Special Village Plan Commission / ZBA Meeting Agenda

5. PUBLIC HEARING AND RECOMMENDATION TO THE VILLAGE BOARD ON AN APPLICATION FOR A SPECIAL USE CONCERNING THE PROPERTY LOCATED AT THE NORTHWEST CORNER OF ROUTE 72 AND CENTER DRIVE (02-24-155-003)

Re: Red Barn Animal Hospital
Preliminary Plan Submission
Review #1

TO: Brian Bourdeau, Village Administrator
FROM: Kevin J. Biscan, PE, PLS, Consulting Engineer
DATE: March 3, 2022
RE: Red Barn Animal Hospital
Preliminary Plan
REL #22-R0333
Review #1

ARCHITECTURAL SITE PLAN

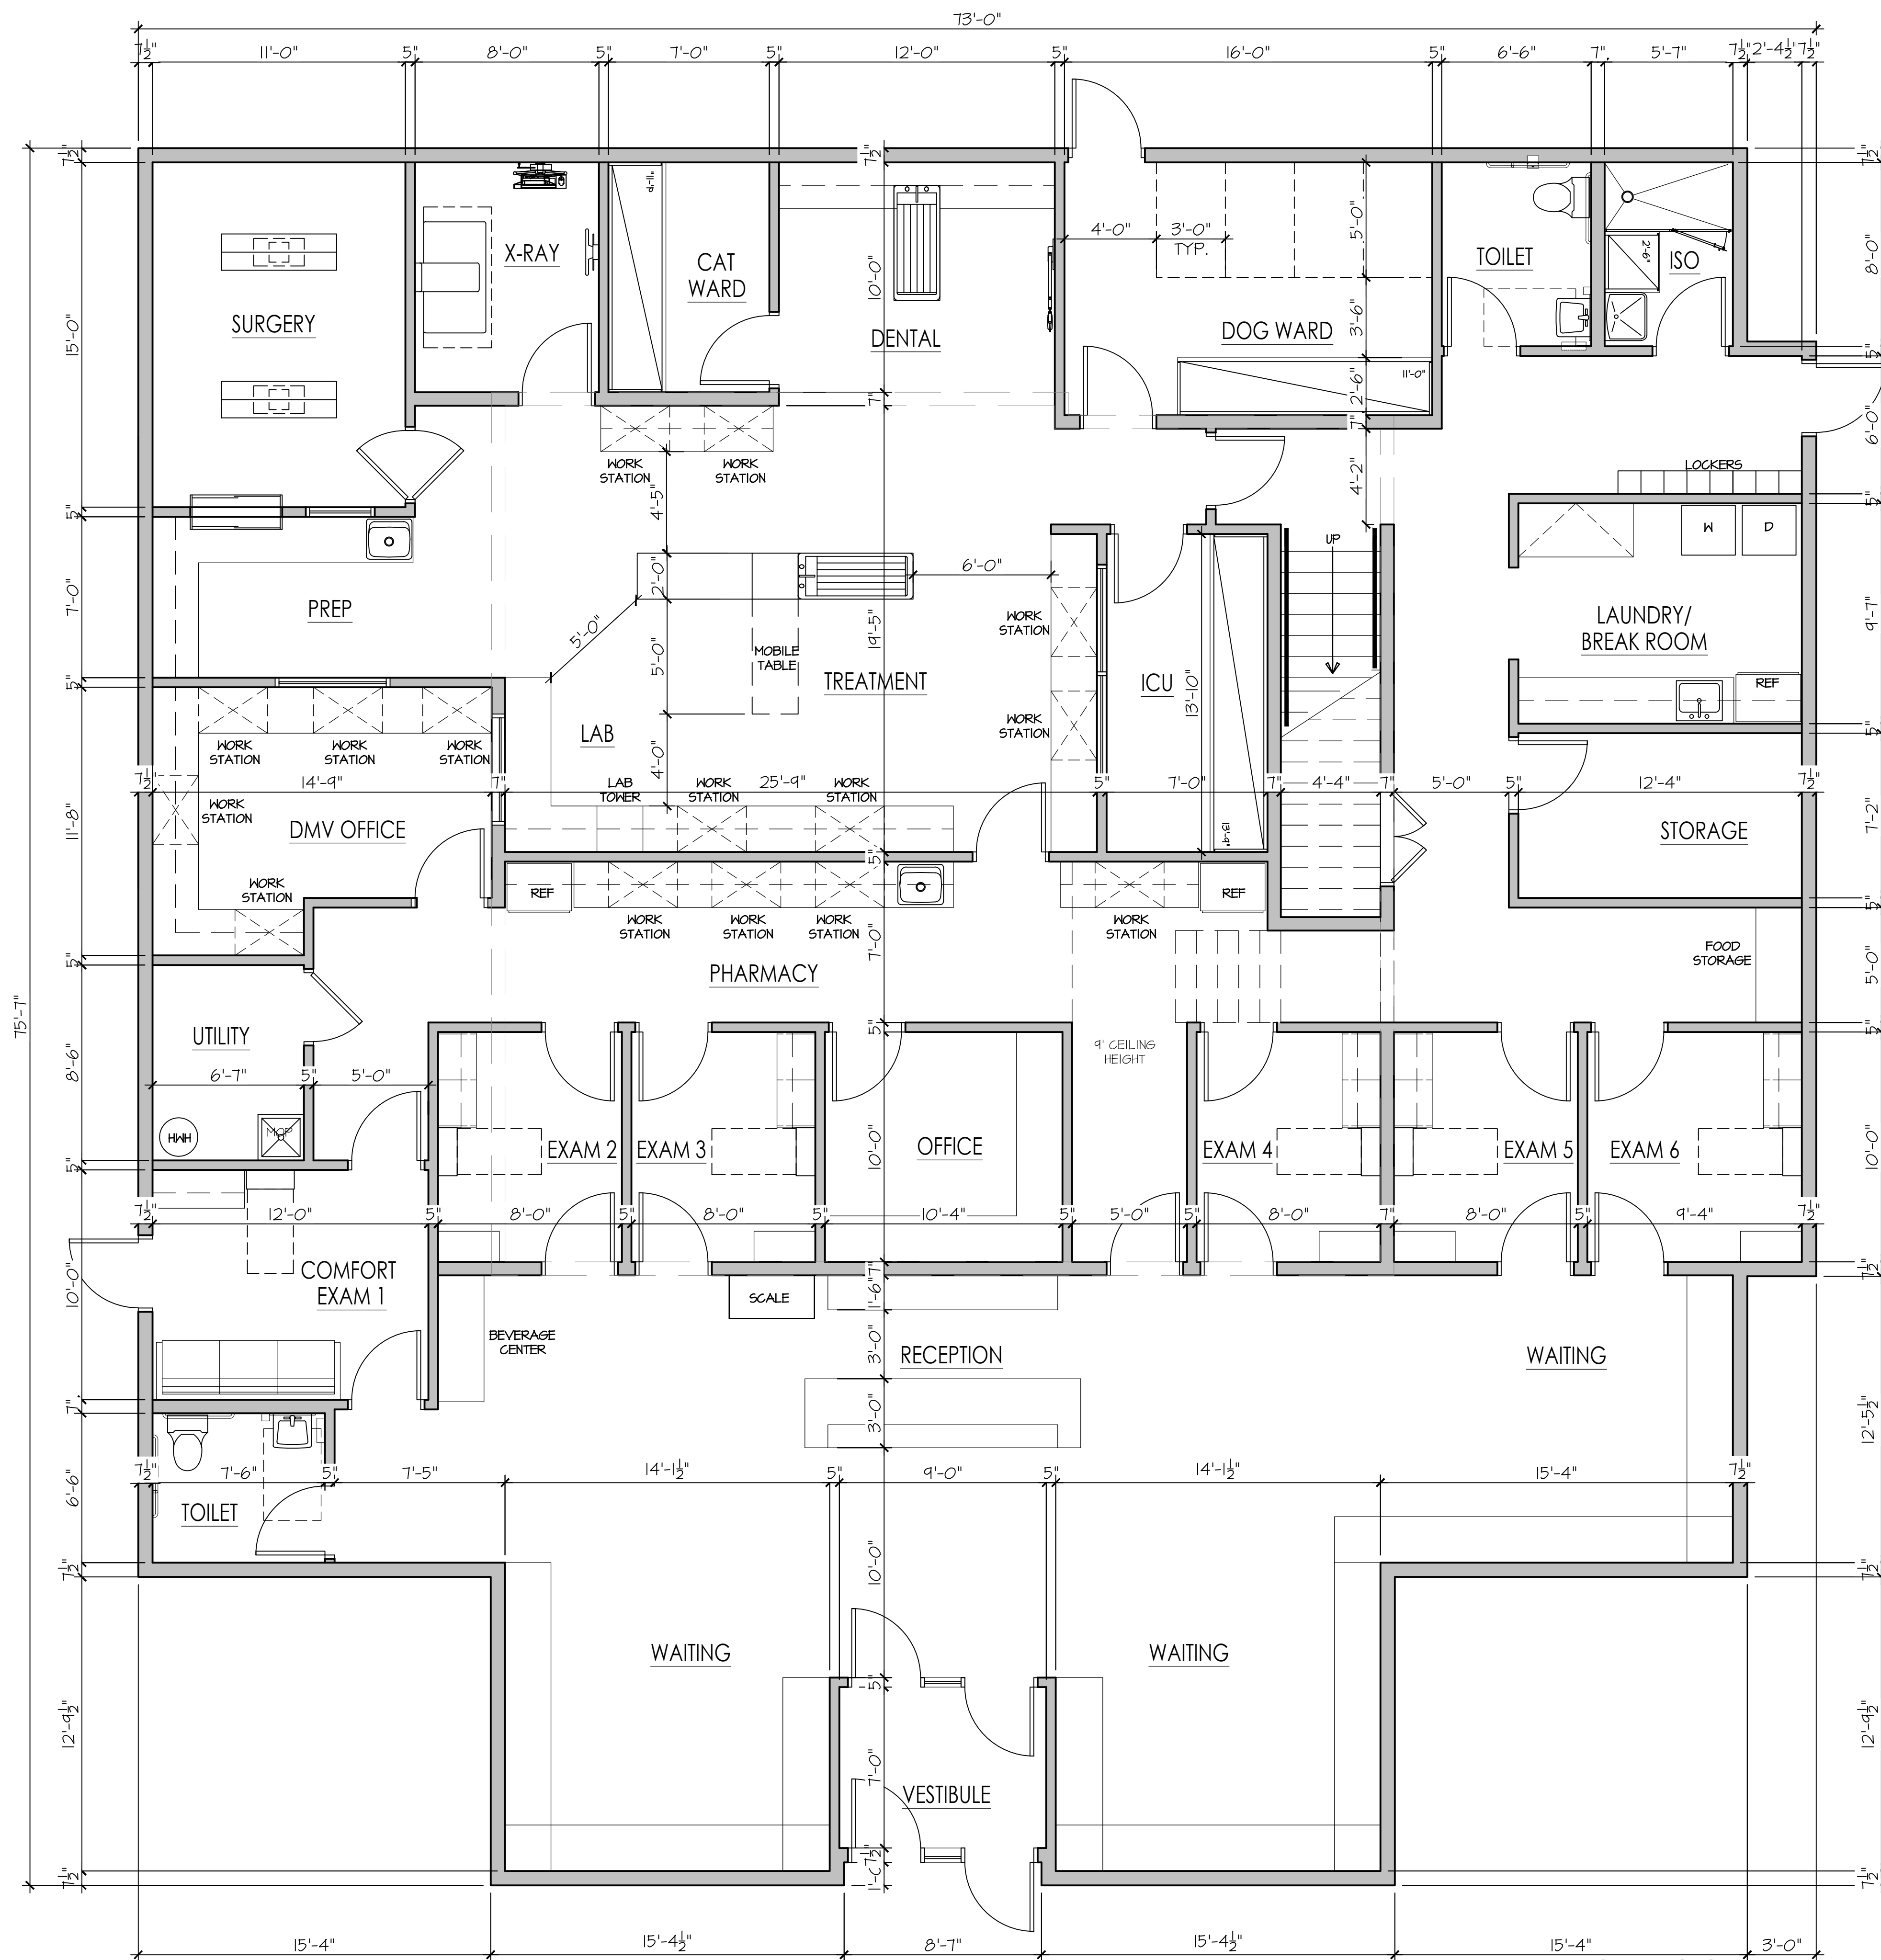
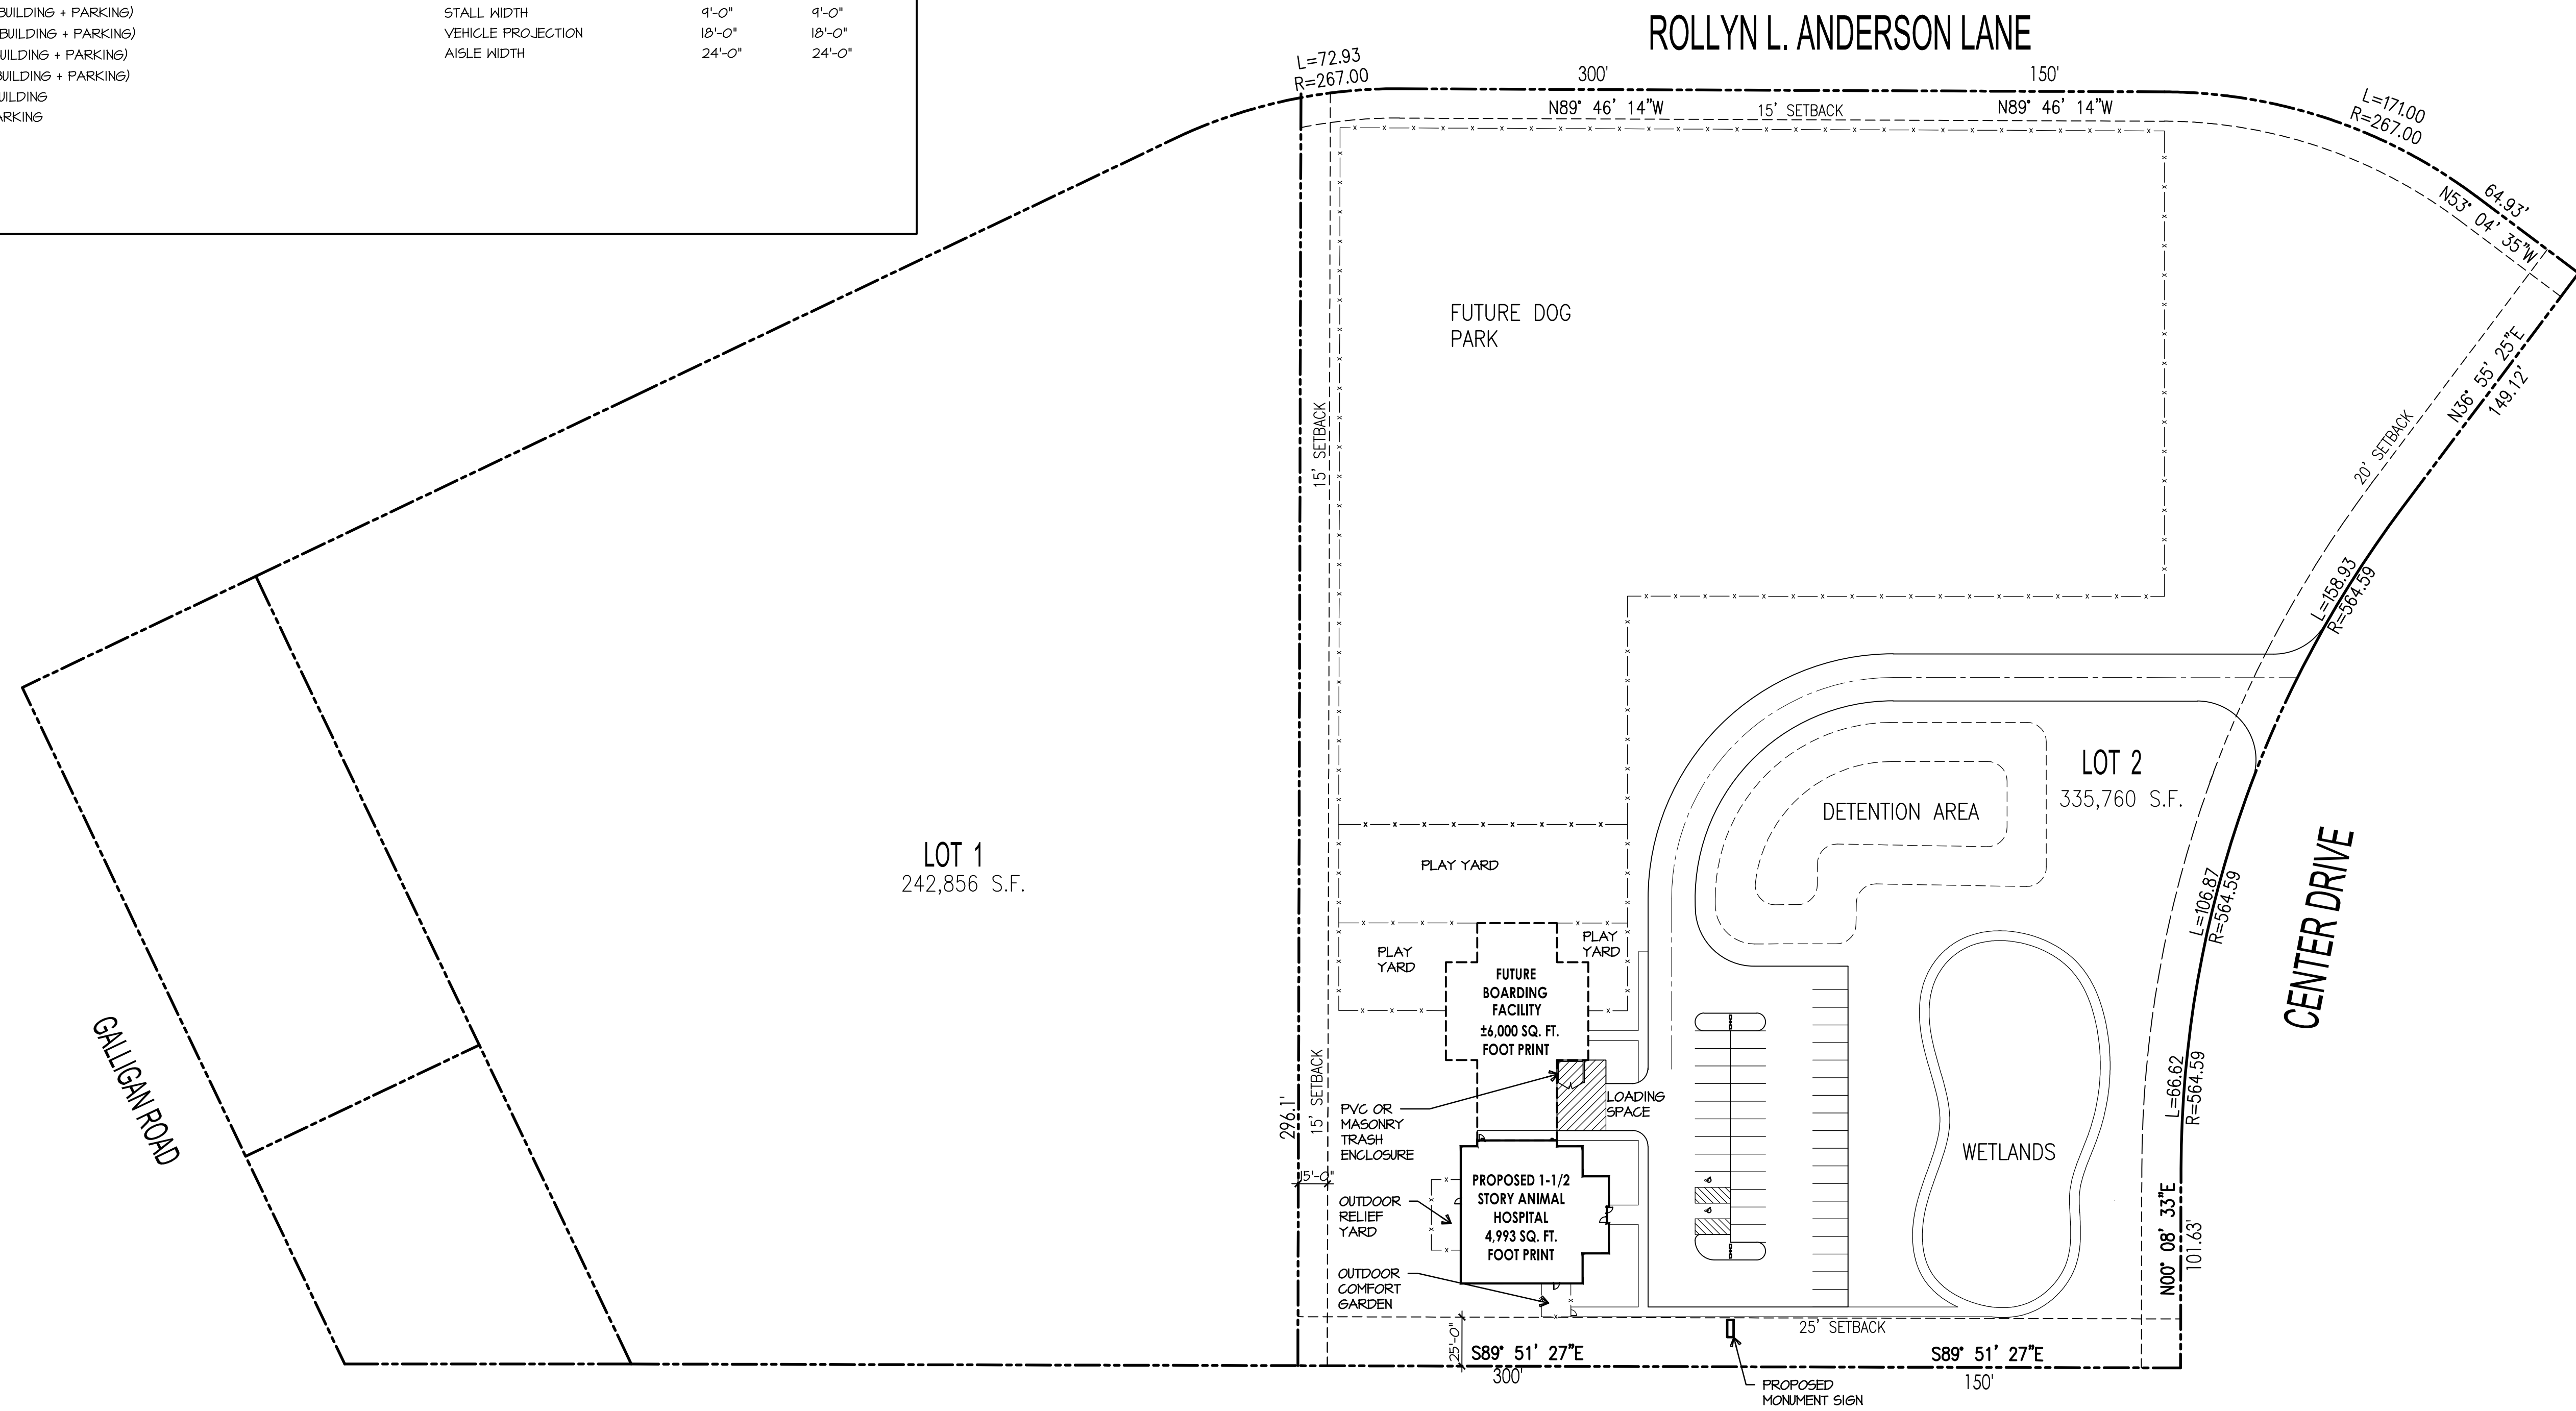
1. Please provide calculations to verify the landscape standards for off-street parking: *"A minimum of 720 square feet of landscaped area shall be provided for each 24 required parking spaces. Any landscaped areas outside the minimum required setbacks may be counted toward this minimum square footage standard. A minimum of three canopy trees, two understory trees and six shrubs must be provided for each 720 square feet of landscaped area..."* (Gilberts Town Center Annexation Agreement, Exhibit G).

3. Exhibit G of the GTC AA, also calls for specific landscaping standards along Higgins, Center, Turner (a.k.a. Rollyn Anderson Ln. east of Galligan). Please verify the submitted landscape plan complies with these requirements.

4. The submitted plans show a loading dock and garbage enclosure as part of the future board facility. Please provide information on the loading dock space and garbage enclosure for the animal hospital building.

5. What type of fencing, including material type, is proposed for the various enclosures (dog run, relief area etc.) shown on the site plan?
6. How does Red Barn intend to ensure the cleanliness of the dog run areas?

10. There is a large open space contained on the northeastern corner of the property. What is the intended use of that area?
11. Please provide a lighting plan and photometric analysis for review pursuant to the GTC AA, Exhibit G and Village UDO 10-9-5.

12. Please provide a calculation of total lot coverage on the site plan.
13. Please provide additional details regarding the freestanding sign that is proposed to be located along IL Route 72. The sign should be in conformance with the sign requirements of the GTC AA, Exhibit G and the Village UDO 10-9-2 et. seq.

14. Please provide the square footage of the proposed building signage to confirm conformance with the GTC AA, Exhibit G.
15. Please review and confirm the quantity and dimensions of the provided off-street parking to ensure compliance with the Village UDO 10-9-1(B).

16. Are there proposed to be any freestanding signage on the property?
17. Please review and ensure the General Standards table on the site plan to ensure it reflects the proper site regulations – GTC AA and/or Village UDO.
